MOTOR COACH  
INDUSTRIES

**SUBJECT: SAFETY RECALL OF WHEELCHAIR LIFT UPPER DOOR WARNING  
AND LATCH**

Ref.: **NHTSA # 09V-345  
TRANSPORT CANADA # 09-254  
MCI Service Bulletin 325B**

# Service Bulletin No. 325B

Figure 3. Gusset installation corner ( top, rearward corner of the lift access compartment ).

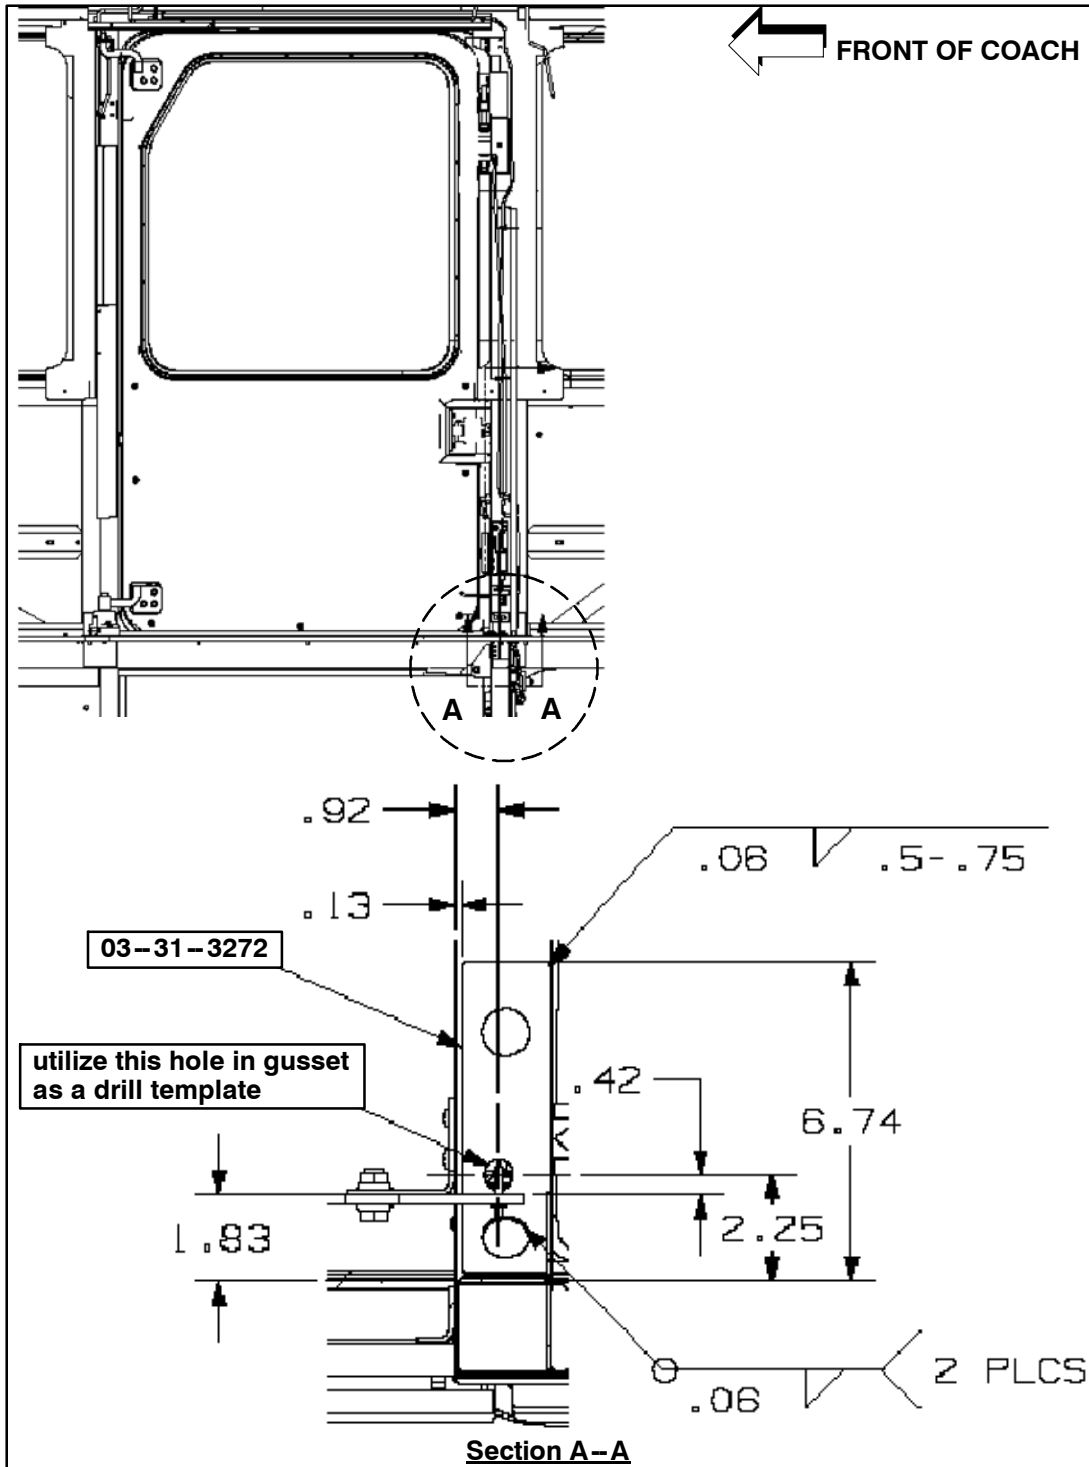
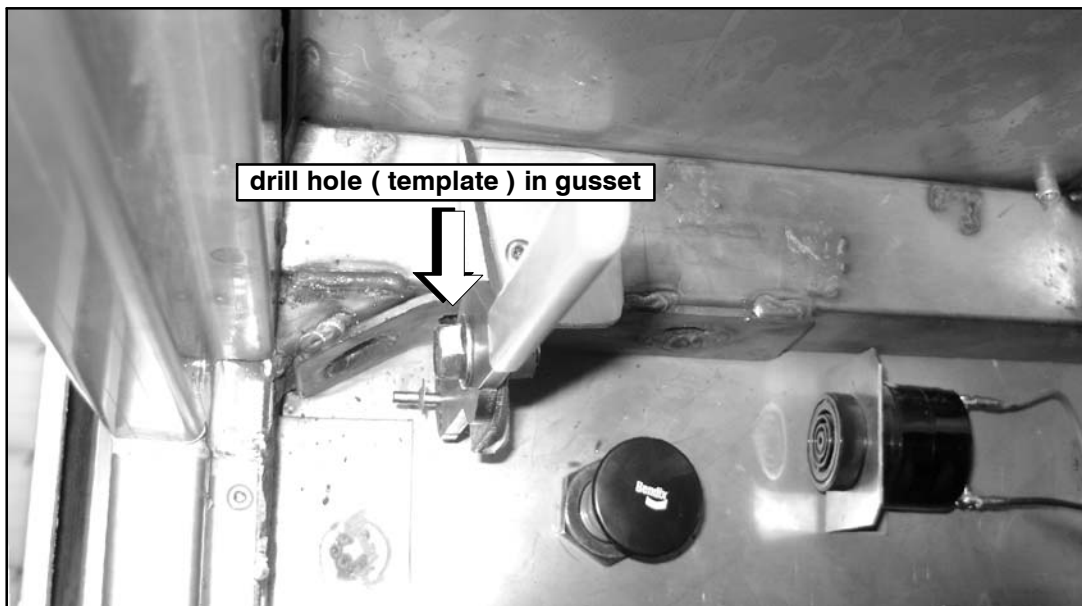
4. Locate and open the lift access compartment door, directly below the sliding wheelchair access door.
5. Using an industrial heat gun and steel brush, clean to remove all the dirt and loose paint or rust from the installation area ( refer to Figures 3 and 4 ).
6. Tack weld the gusset ( p/n 03-31-3272 ) into position, according to Figure 3.
7. Weld the gusset, using the weld sizes and locations in Figure 3.

Figure 5.

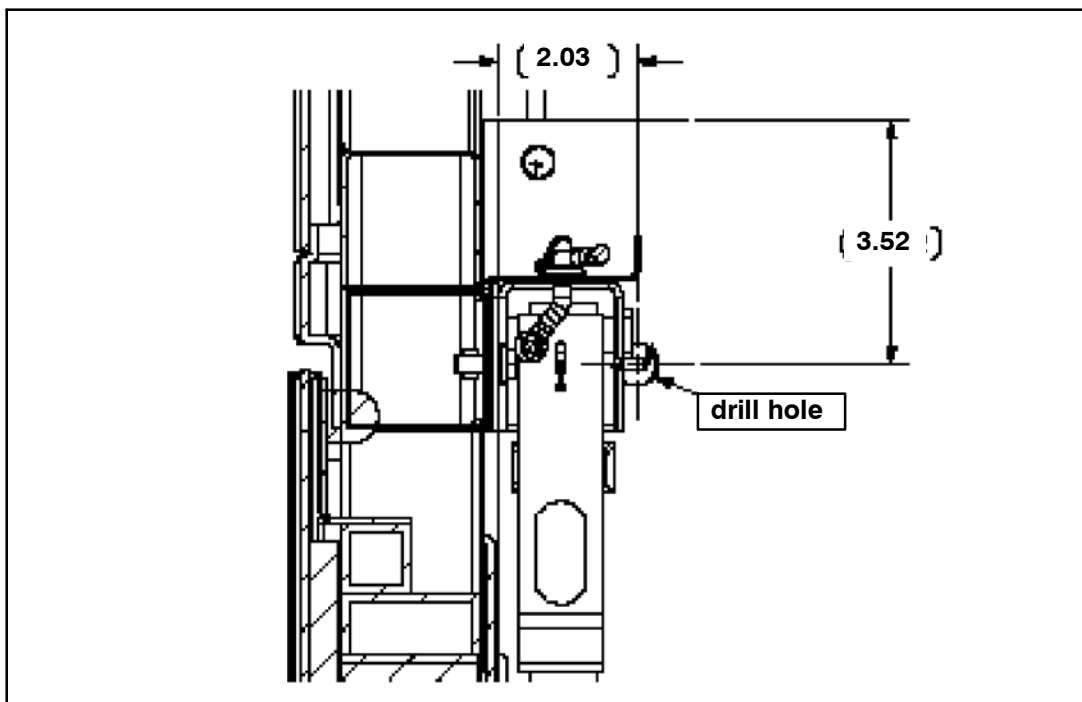
- 8. Using a 0.63 inch drill bit and the hole in the gusset as a template, drill a hole up through the tube frame and floor per the dimensions shown in Figure 5 into the coach cabin ( refer to Figures 3 and 4 for hole location on gusset ).

**Figure 6. installation dimension.**

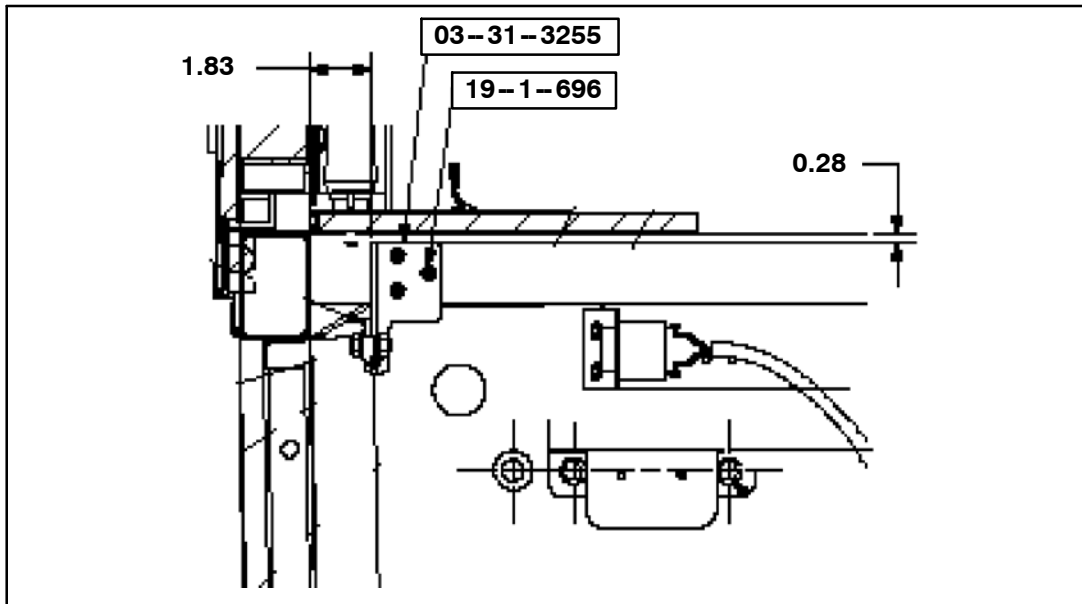
9. Position bracket, lever, p/n 03-31-3255, as shown in Figures 6 and 7.

**Figure 8.**

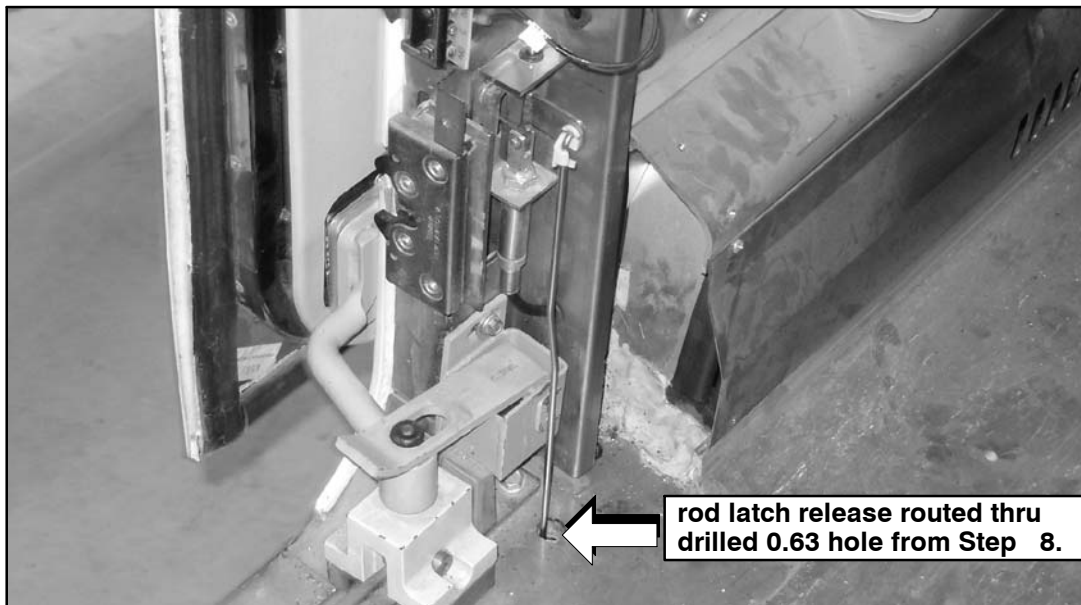
12. Remove and retain the four (4) mounting screws from the existing lever assy–latch. Discard existing lever assy–latch. Using the four (4) mounting screws, install the new lever assy–latch, p/n 03–31–3257 (refer to Figure 8). Tighten screws to secure.

**Figure 9.**

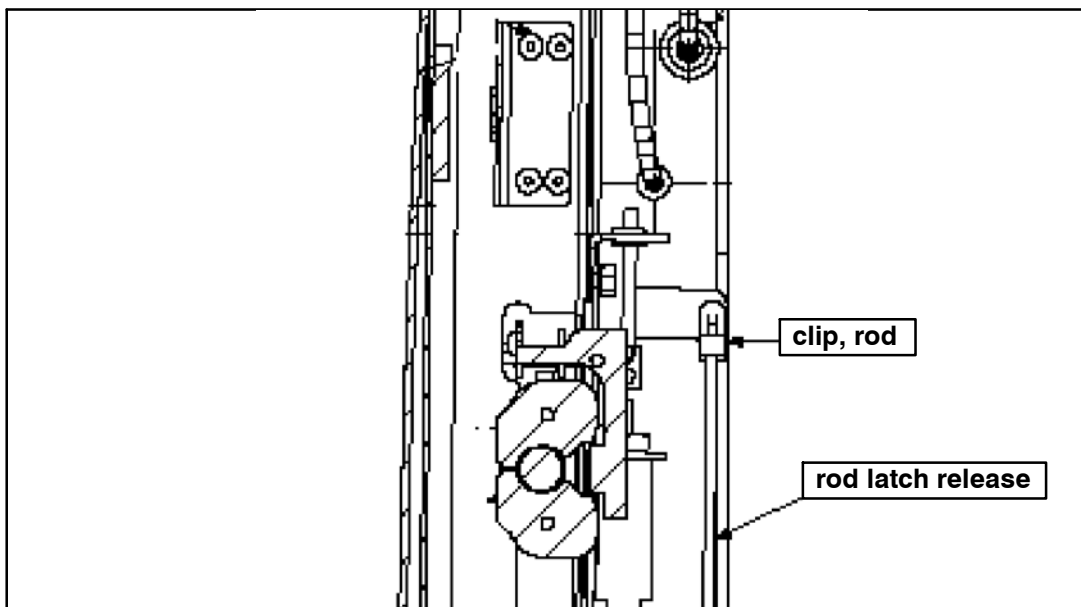
13. Align and route the rod latch release, p/n 03–31–3258, thru the drilled hole (refer to Figure 8). Using the clip rod, p/n 03–31–1100, install the rod latch release as shown in Figure 9 (refer to Figures 9 and 10).

Figure 12.

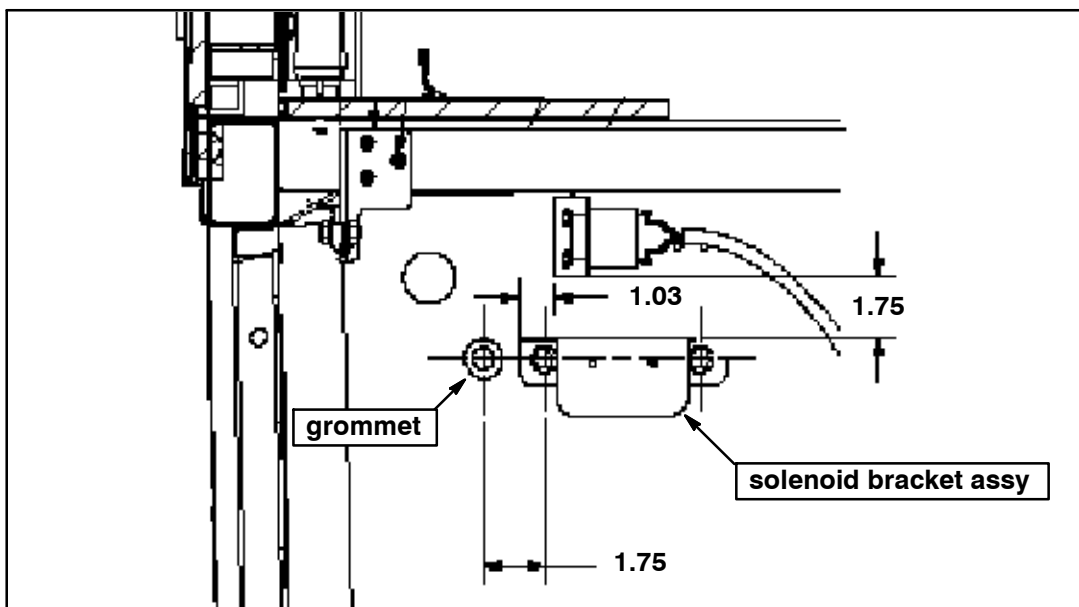
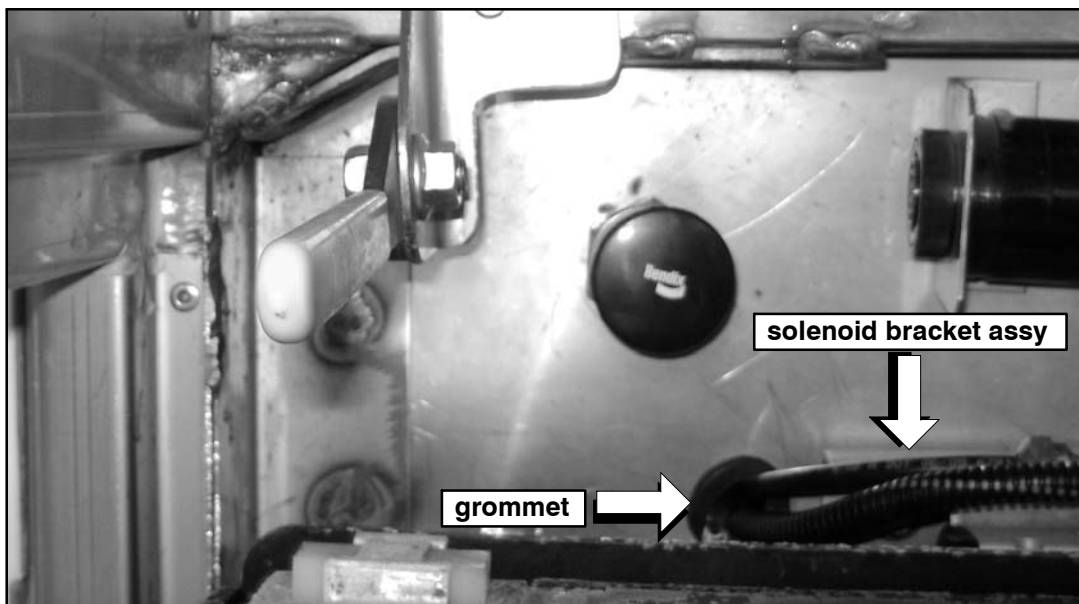
15. Position the solenoid bracket assy, p/n 03-31-3265, on the side panel of the lift access compartment as per dimensions shown in Figure 12 ( refer to Figures 12 and 13 ).
16. Using a 0.34 inch drill bit and the two (2) holes in the solenoid bracket assy as a template, drill two (2) mounting holes. Using capscrew, p/n 19-1-16, fender washer, p/n19-2-187 and locknut, p/n 19-3-183, securely mount the solenoid bracket assy to compartment wall.
17. Using a 0.87 inch drill bit, drill a hole as per dimensions shown in Figure 12. Install grommet, p/n 19-12-20, in drilled hole ( refer to Figures 12 and 13 ).

Figure 15.

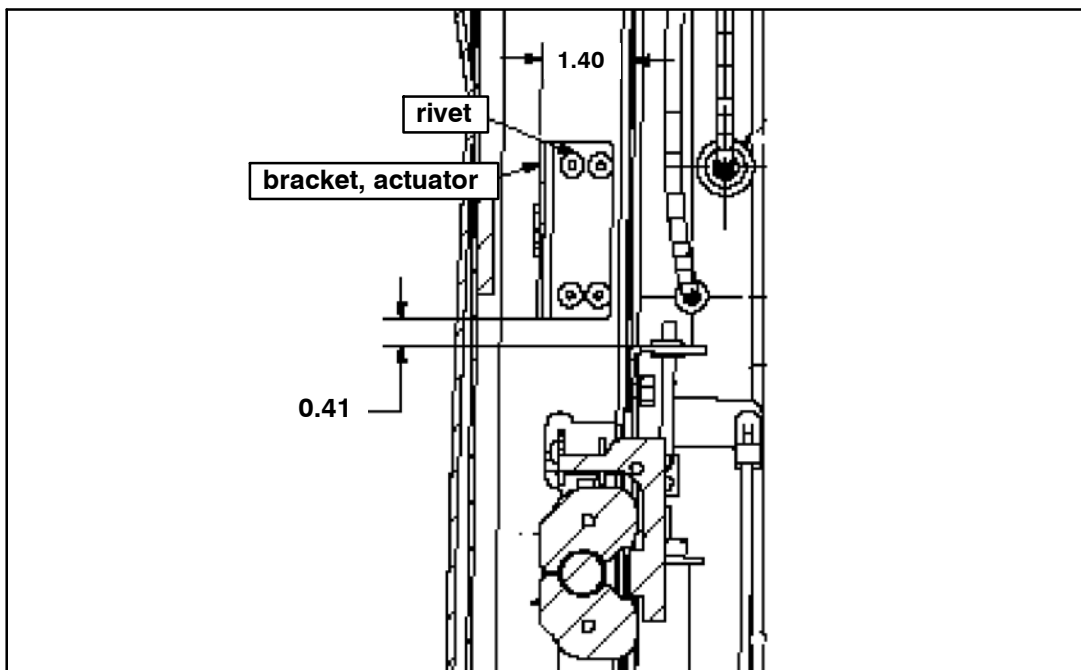
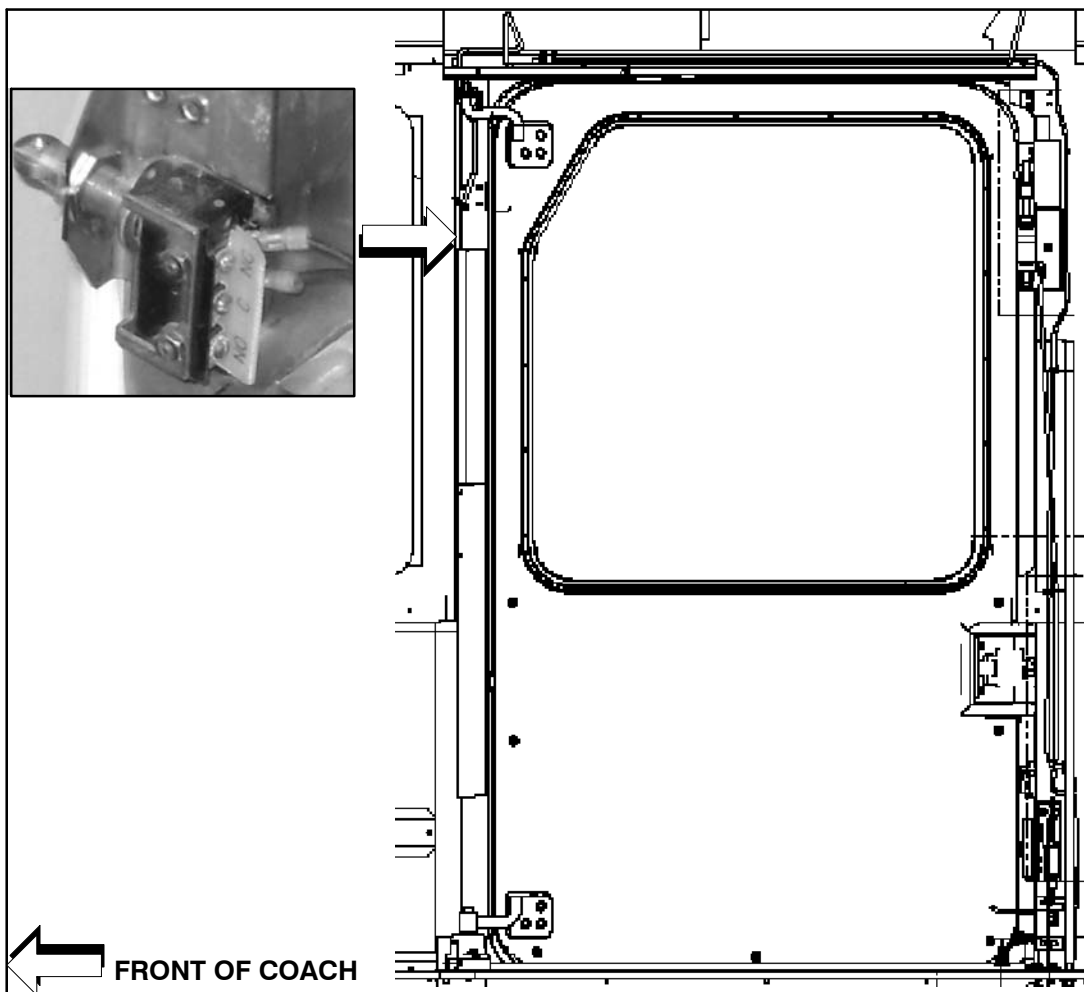
19. Using the two dimensions ( 1.40 and 0.41 ) shown in Figure 15, position the bracket, actuator, p/n 03–31–3281, and secure in place. Using a 0.20 drill bit and the four (4) holes in the bracket, actuator as a drill template, drill four mounting holes into the frame. Using rivets, p/n 19–13–137, mount the bracket, actuator to the frame ( refer to Figures 15 and 16 ).

**Figure 19.**

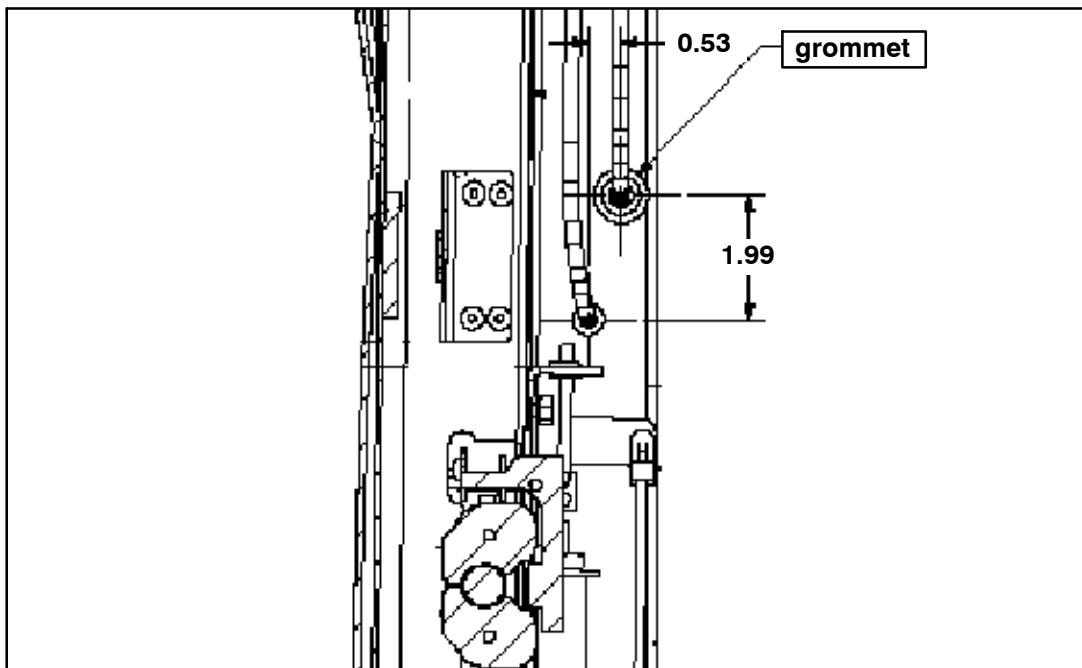
22. Using the two dimensions ( 1.99 and 0.53 ) shown in Figure 19, and a 0.62 drill bit, drill a hole into the frame. Install grommet, p/n 19-12-4, in hole.

**Figure 20.**

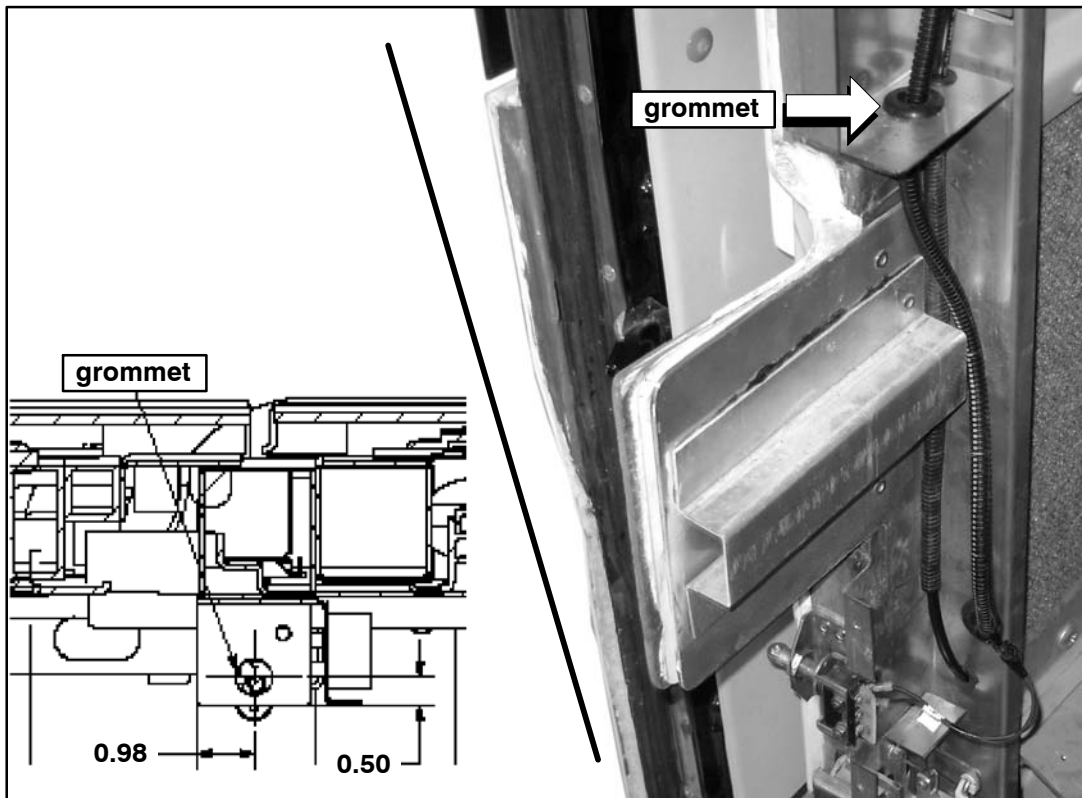
23. Using a 0.62 inch drill bit, drill a hole as per dimensions shown in Figure 20. Install grommet, p/n 19-12-4, in drilled hole ( refer to Figure 20 ).
